### **New Castle Planning and Zoning Commission Public Hearing Wednesday, March 25, 2026, 7:00 PM**

- A. Consider Resolution No. PZ 2026-3 A RESOLUTION OF THE NEW CASTLE  
PLANNING AND ZONING COMMISSION RECOMMENDING APPROVAL OF  
A CONDITIONAL USE PERMIT FOR AN ELECTRICAL SUBSTATION IN THE  
INDUSTRIAL ZONE DISTRICT**

**RE: Coal Ridge Substation  
Engineering Comments for C.U.P.**

**Planning Commission – Public Hearing**  
**Wednesday, March 25, 2026**  
**Resolution PZ 2026-3**  
**Staff Report**

**ATTACHMENT B: LANDSCAPE PLAN**

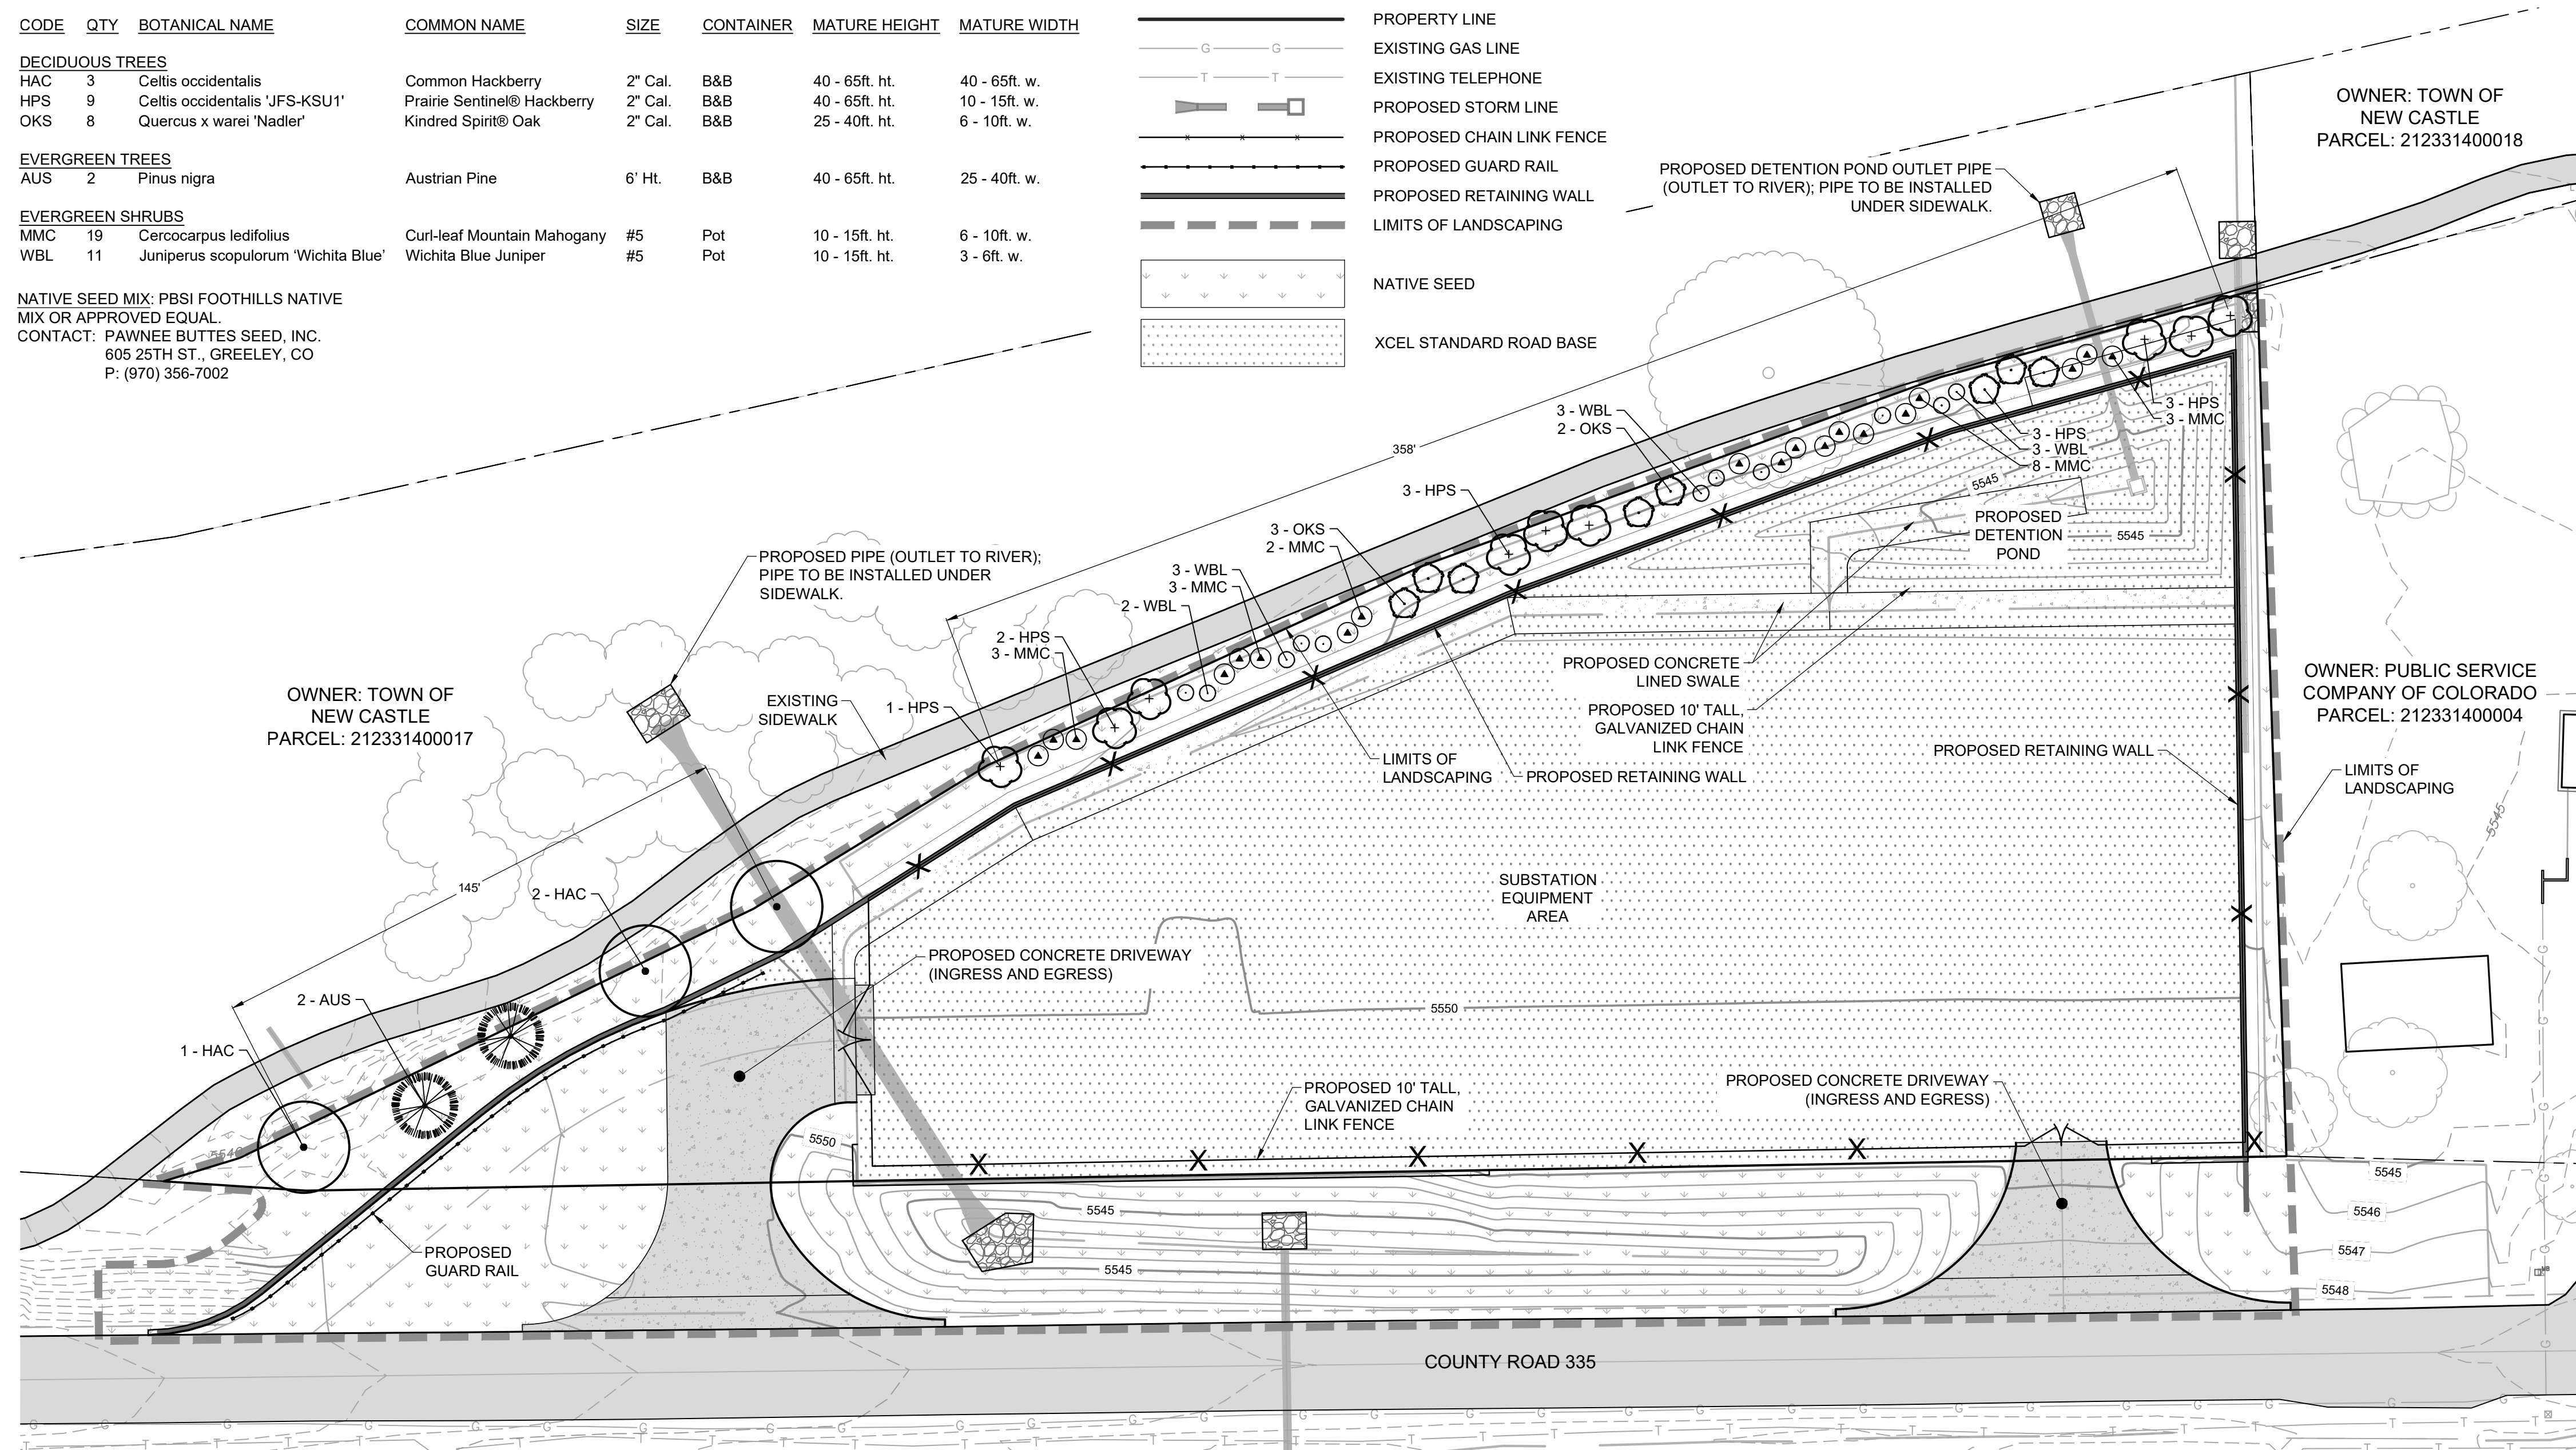
Because of the structure’s considerable height and visual impacts to properties both adjacent and further towards the north, Staff has worked with the Applicant to expand the screening to the greatest extent possible. Additional trees have been added to the southern property line to attenuate visual impacts to users of the bike path and onlookers from New Castle’s downtown area. Additional screening may be necessary on the west aspect to comply with “25%” code requirement.

5. The Applicant shall apply for any right-of-way permits through the Town's Public Works Department.
6. Applicant shall add vegetative screening along the west property line pursuant to section 17.52.060. The approved constructions drawings shall demonstrate conformance with the landscaping, screening, retaining wall, and berm designs provided in the application.
